Planning Comments V1 -

**GEOLOGIC HAZARDS EVALUATION AND
PRELIMINARY GEOTECHNICAL INVESTIGATION
THE COVE AT WOODMOOR
DEER CREEK WAY AND BURNING OAK WAY
WOODMOOR, COLORADO**

PUDSP-22-008

**Location of
 Exploratory
 Borings**

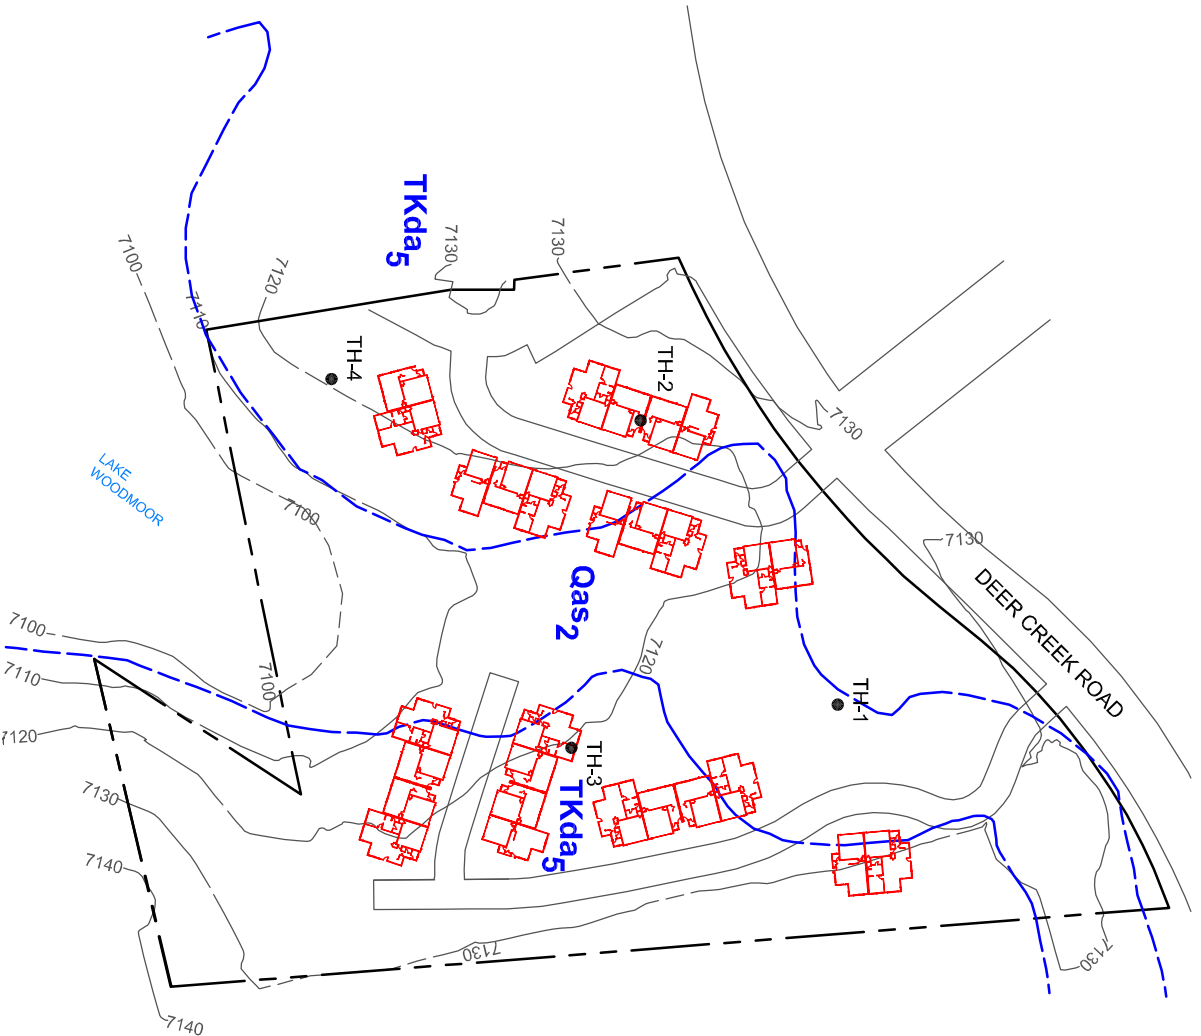
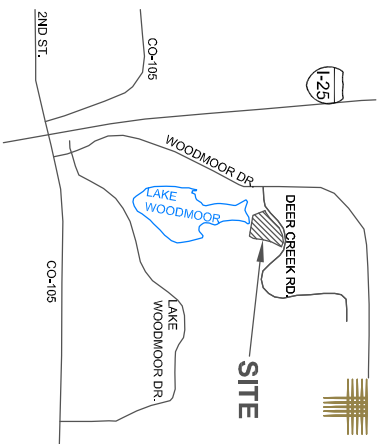
Not the current proposal. please update
